RHODE ISLAND DEPARTMENT OF TRANSPORTATION

Rt 5 - Lambert Lind Hwy C-1 (Mayfield Ave - I-95)

NOTICE TO PROSPECTIVE BIDDERS

ADDENDUM NO. 1 Prospective bidders and all concerned are hereby notified of the following changes in the Plans, Specifications, Proposal and Distribution of Quantities for this contract. These changes shall be incorporated in the Plans, Specifications, Proposal and Distribution of Quantities, and shall become an integral part of the Contract Documents.

CONSTRUCTION DETAILS - 2

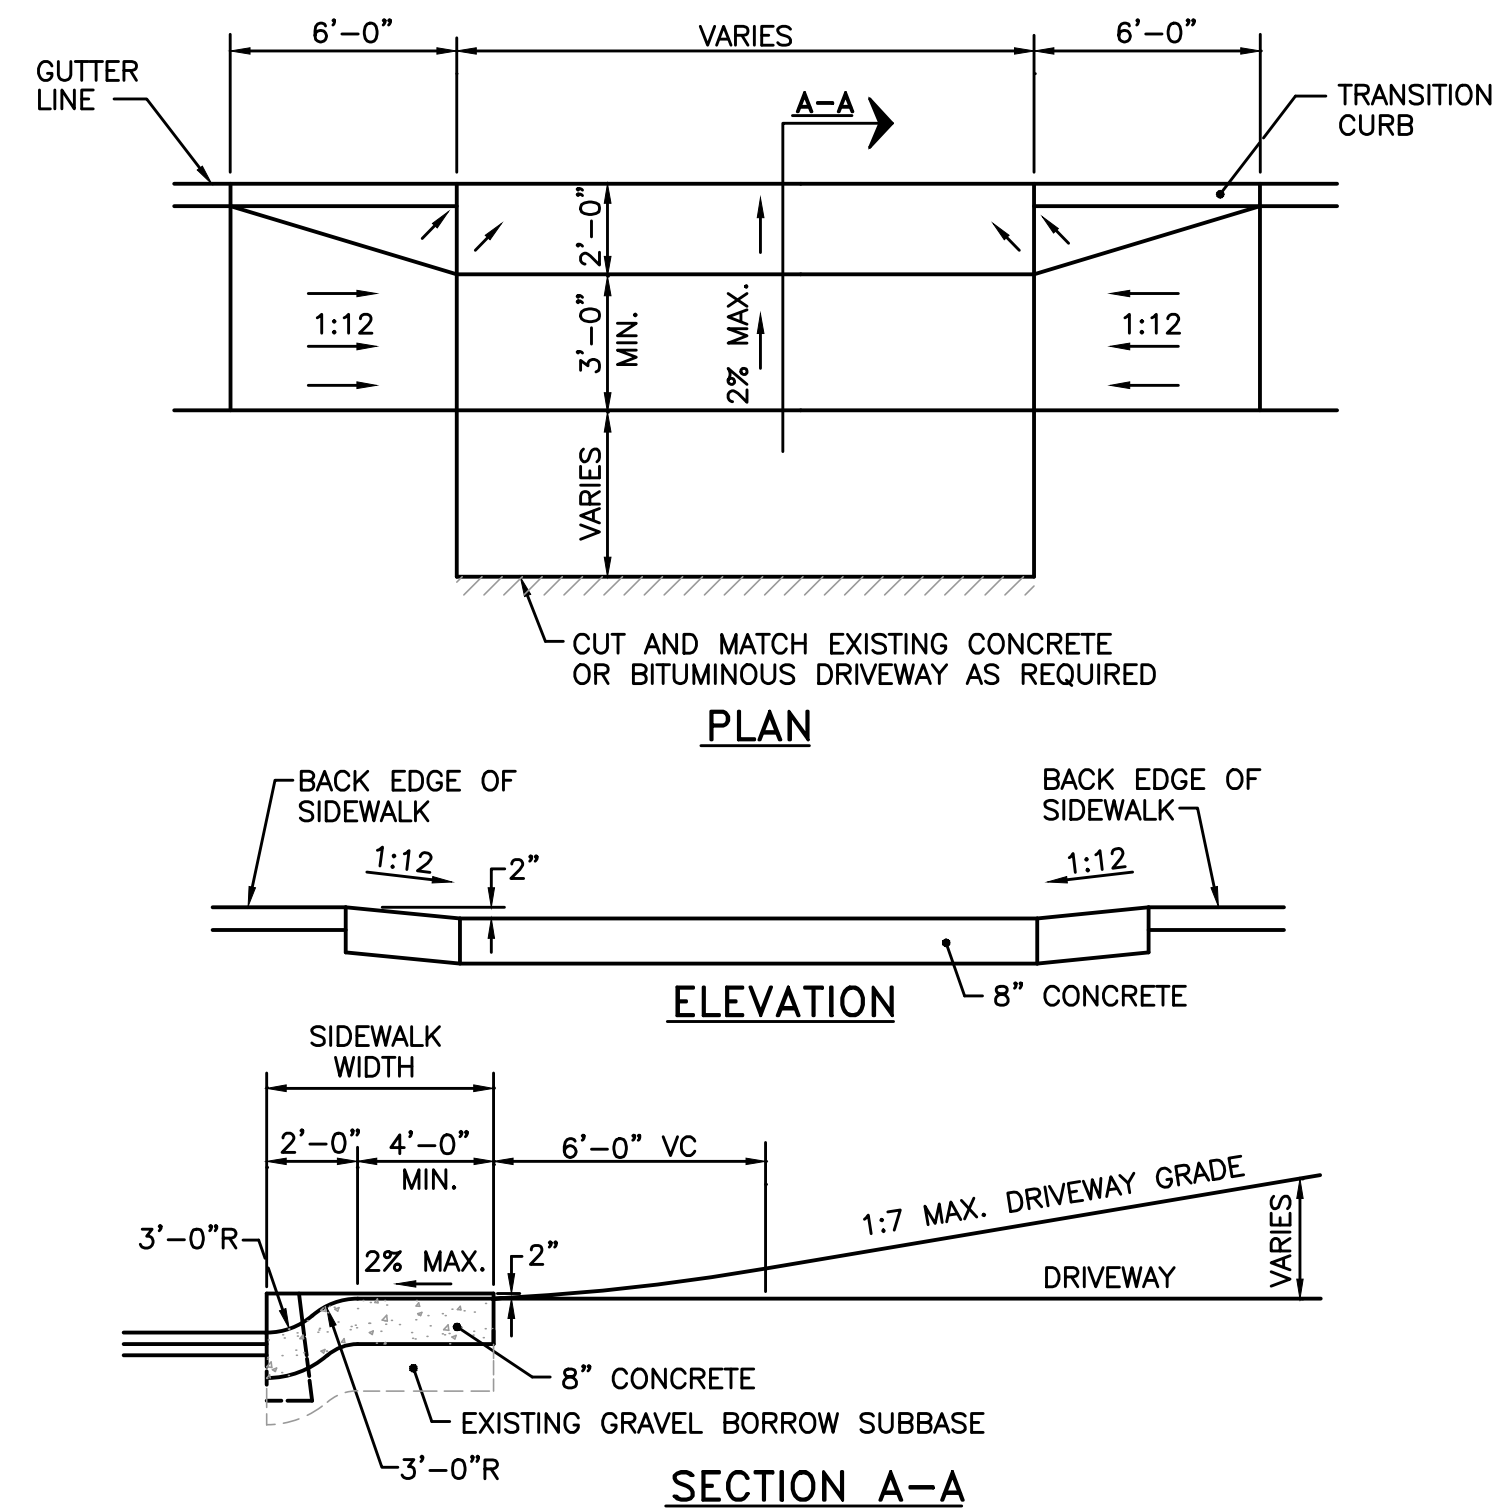
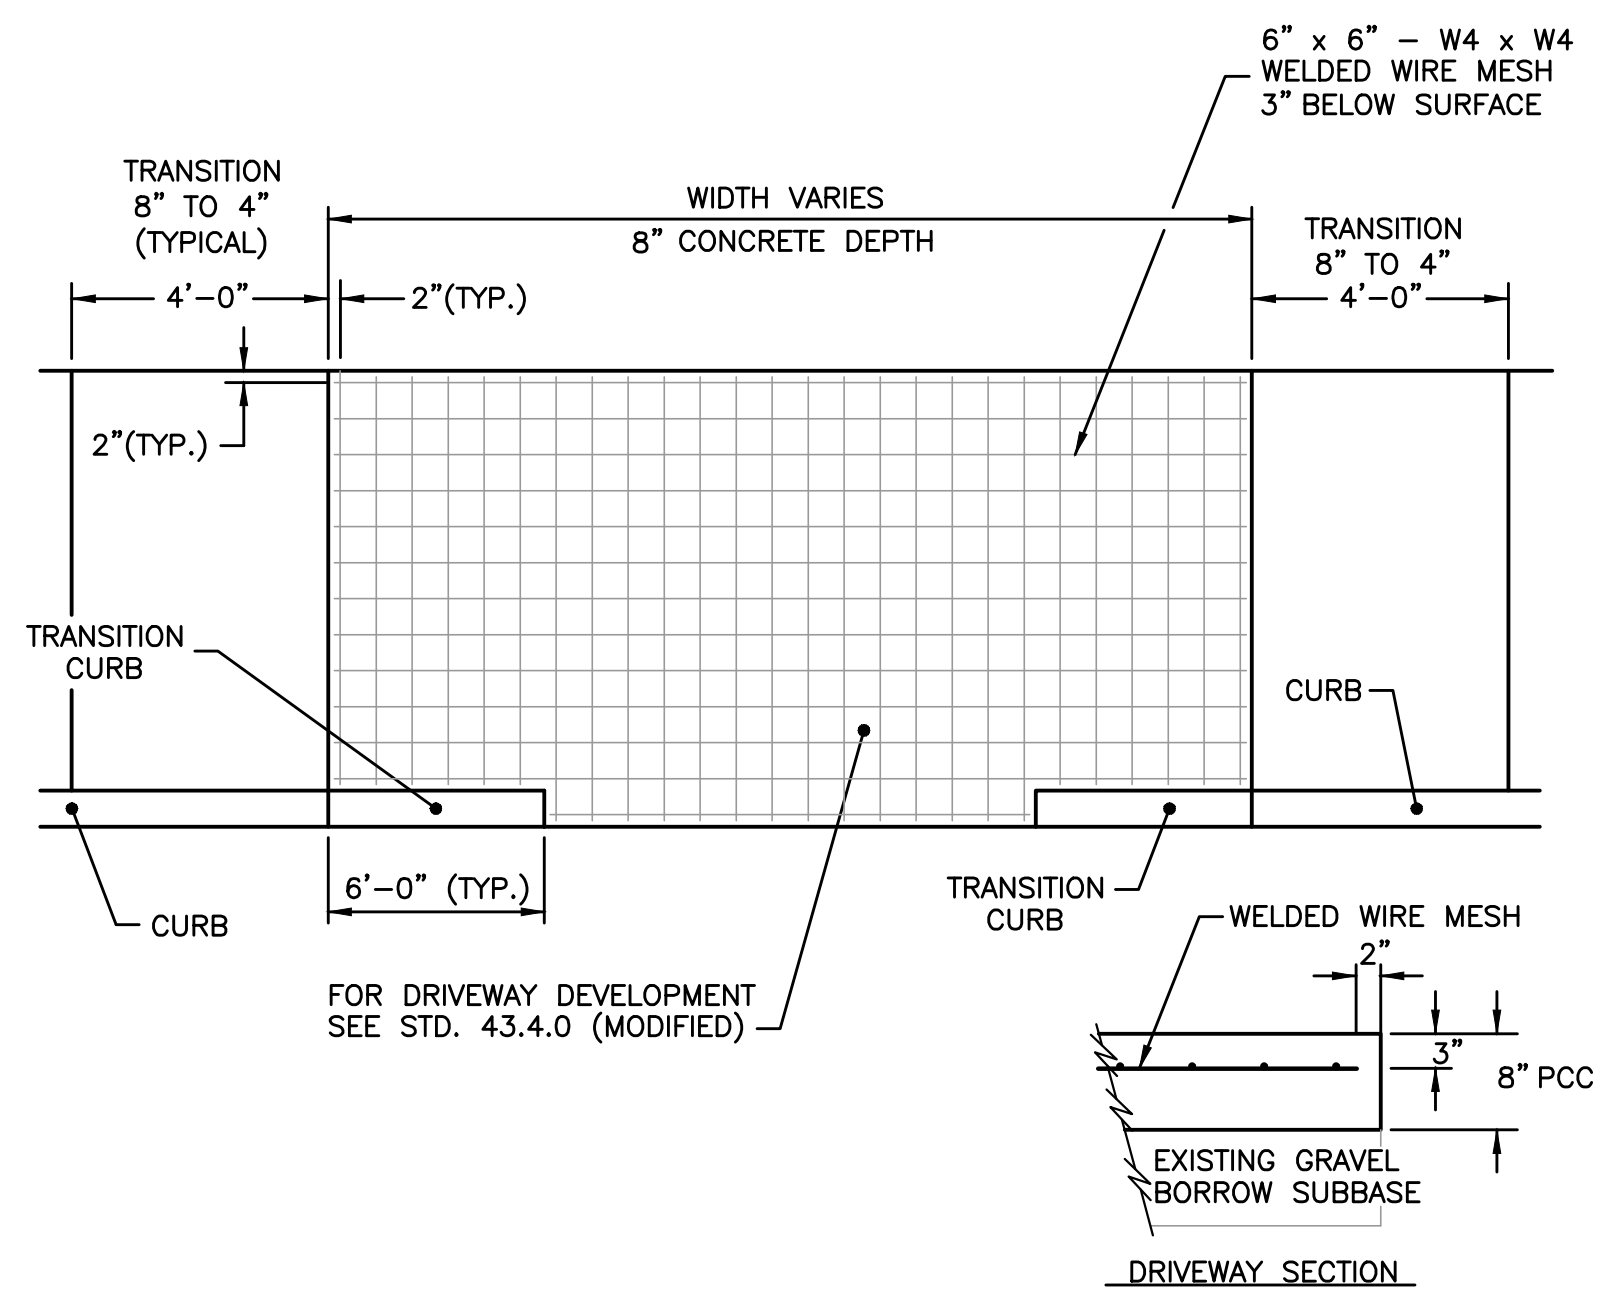
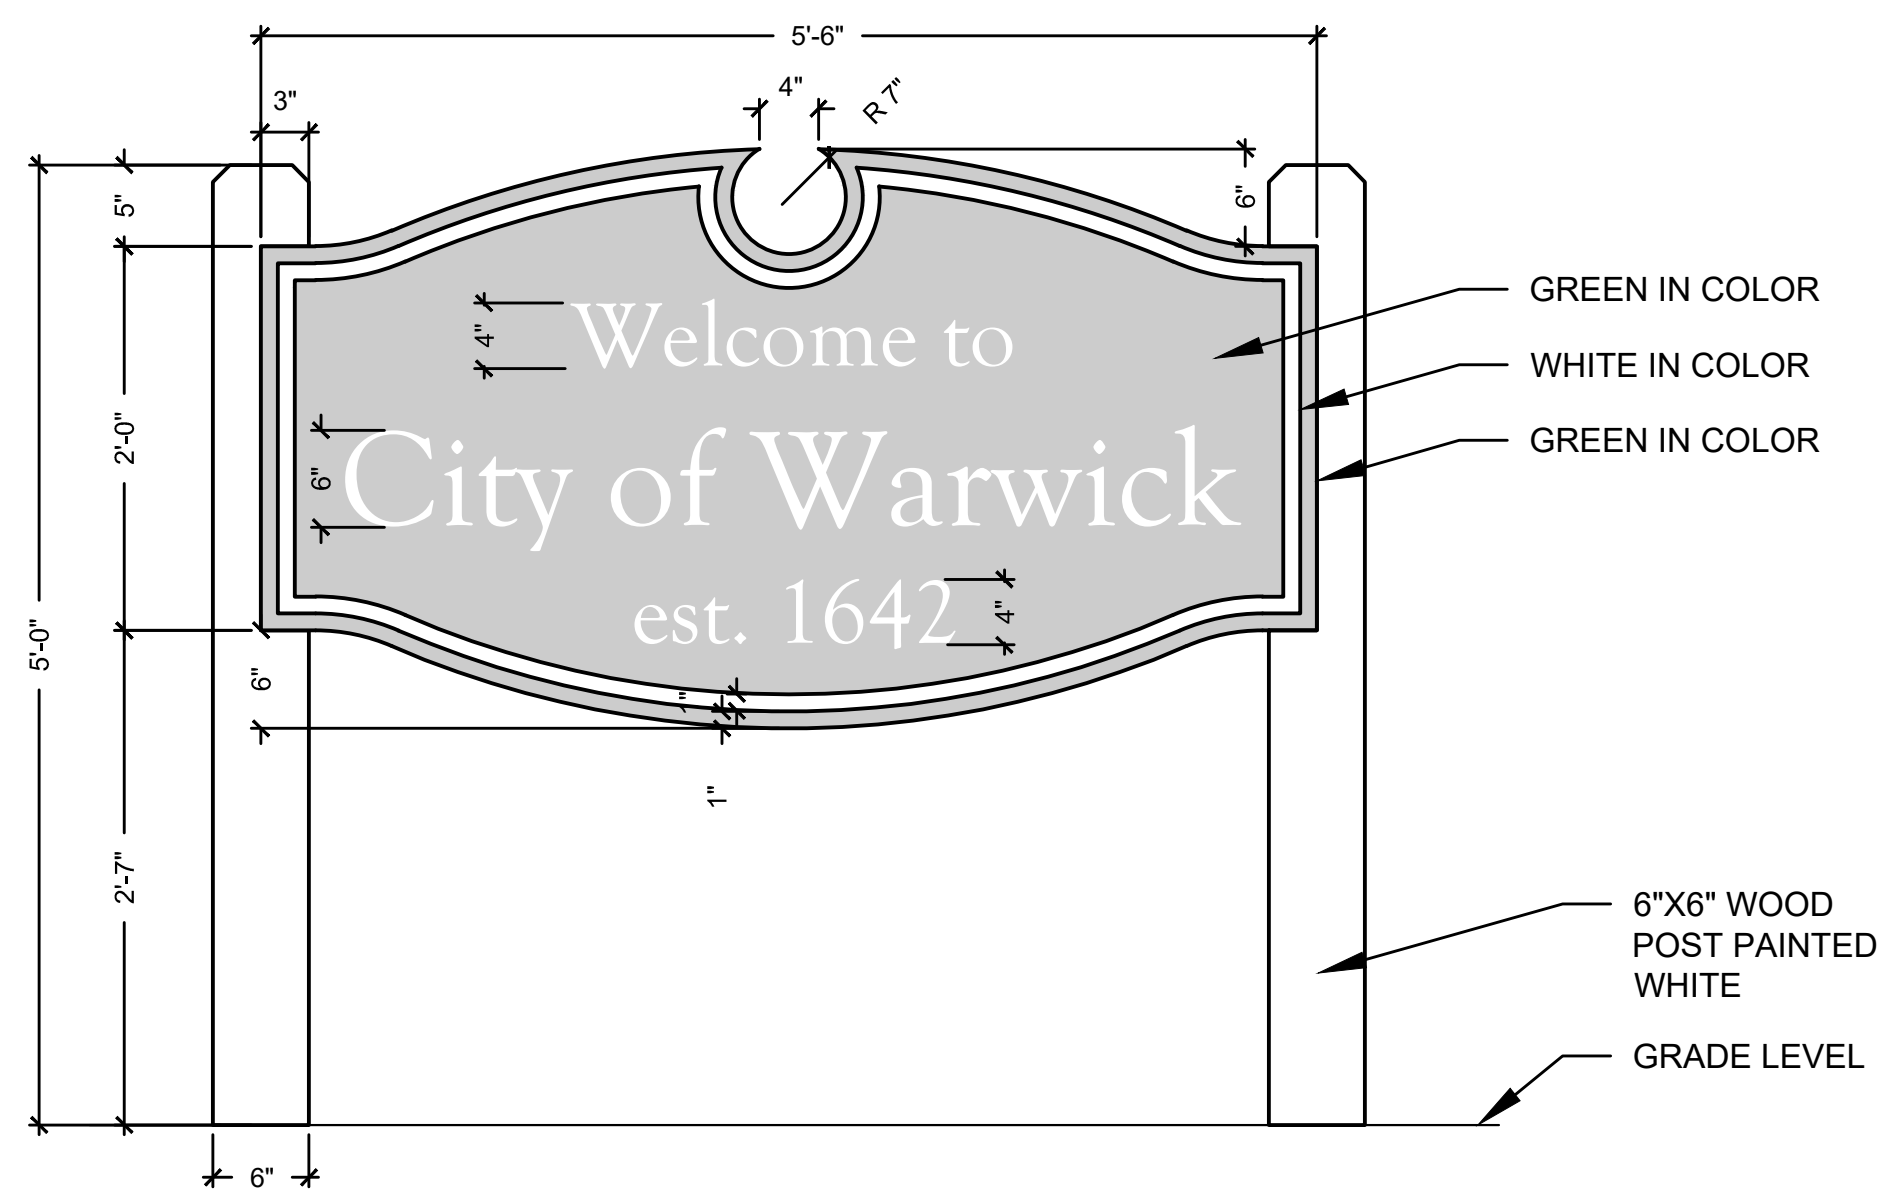
Sheet #34 - Construction Details #2 shows slope faced concrete curbing in the island areas with exposed aggregate sidewalks (item #92). Please indicate the bid item this curbing will be paid for.
